Project	IEEE 802.16 Broadband Wireless Access Working Group < http://ieee802.org/16 >	
Title	Data Transfer Related PHY Primitives Example	
Date Submitted	2001-01-18	
Source(s)	Gregorio Núñez Alcatel Spain, S.A. C/ Ramírez de Prado, 5 28045 MADRID SPAIN	Voice: +34 913395569 Fax: +34 913305094 mailto: goyo@alcatel.es
Re:	This document clarifies the example of the primitives interchanged between PHY and MAC for Data Transfer. It is submitted in response to the “Call for comments on IEEE802.16.1/D1-2000 (Draft standard for Air Interface for Fixed Broadband Wireless Access System).	
Abstract	This document depicts the sequence of primitives interchanged between BS MAC and BS PHY, and between SS MAC and SS PHY to carry out one downlink and one uplink burst transmission. This figure has been performed taking into account the primitive definitions included in the current IEEE802.16.1/D1-2000 standard version.

Data Transfer Related PHY Primitive Example

Figure 118 – Data Tx/Rx Downstream Primitives

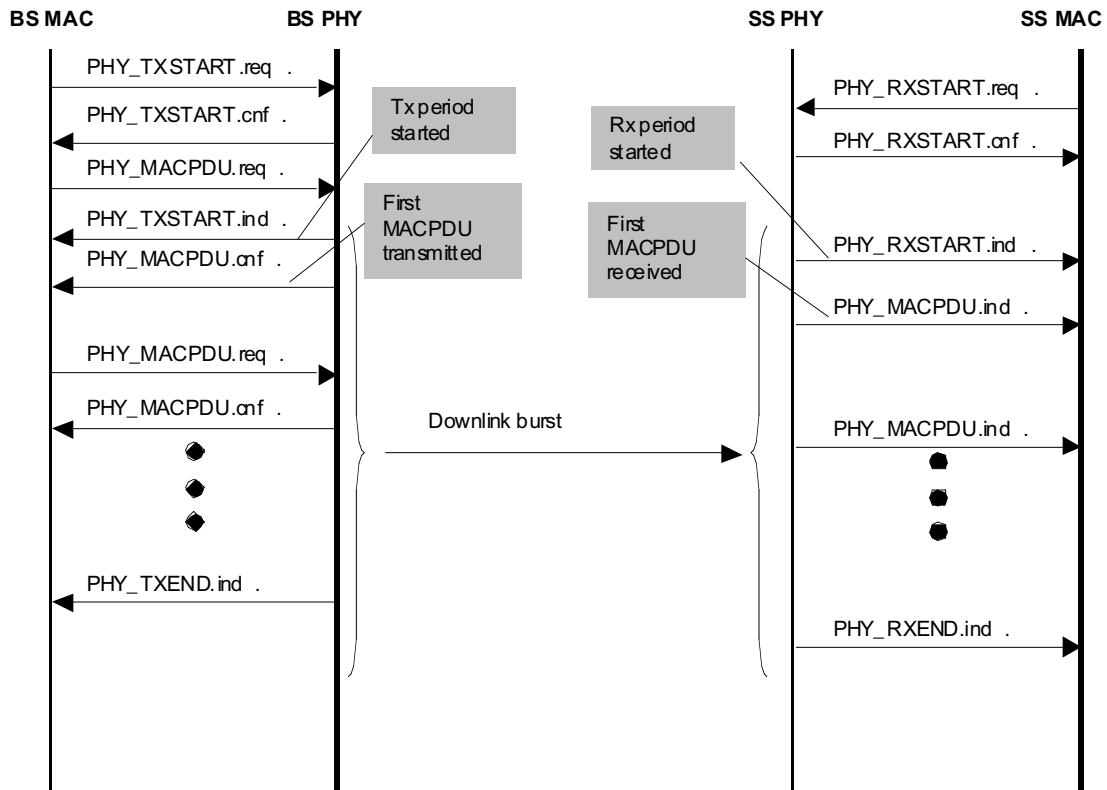
In other words, this figure is intended to replace figures 118 and 119 of the current standard version (page 213).

As it has been already mentioned, the example depicted in the following figures is proposed to be included into the IEEE802.16.1/D1-2000 standard, removing the figures 118 and 119 currently included.
